Petition: #10-24  
Public Hearing:  
01/09/24

**PUBLIC HEARING MEMORANDUM**

**SUBJECT:** **Petition #10-24**, for SPECIAL PERMIT/SITE PLAN APPROVAL to allow three single-family attached dwellings in two buildings, to waive certain dimensional requirements and one parking stall at 199 Church Street

**199 Church Street**

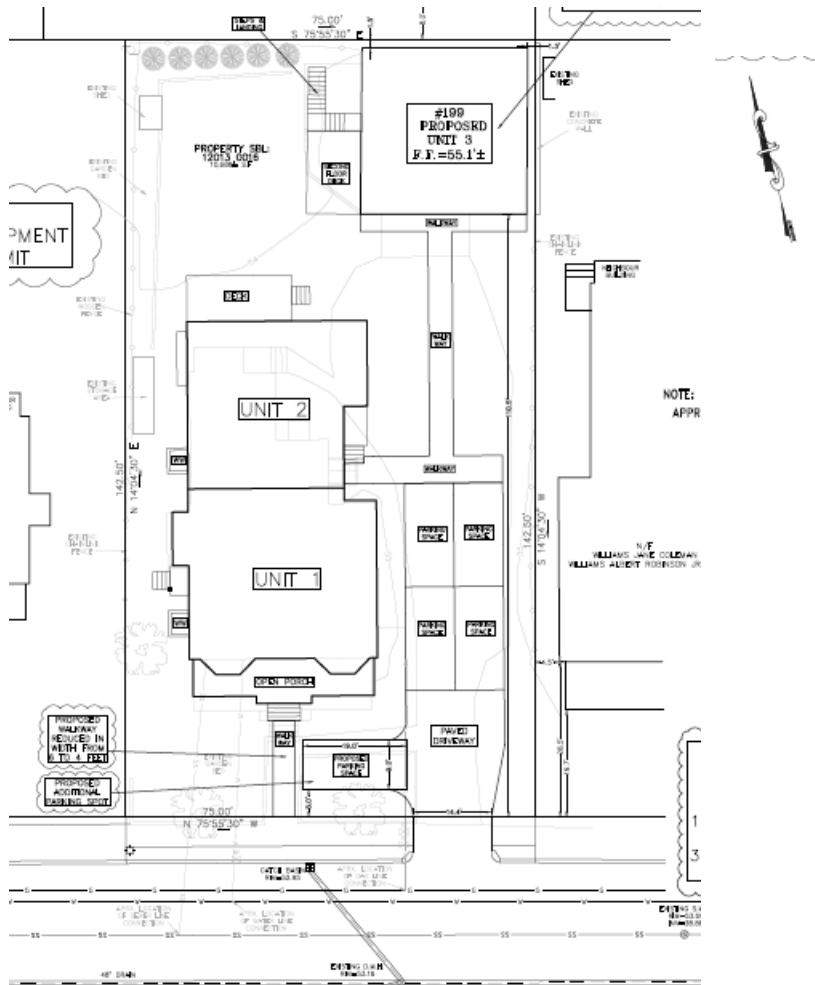
The changes proposed on the site are limited to the construction of one parking stall in the front setback, and a paved walkway from the street to the front entrance of the front building.

The new stall will be 19 by 9 feet in size, parallel to the front façade of the building. This stall requires relief as it is located entirely within the front setback from Church Street. Because it will be so close to the street, staff recommend the applicant consider relocating this stall further back or utilizing pervious pavers to facilitate drainage on the site.
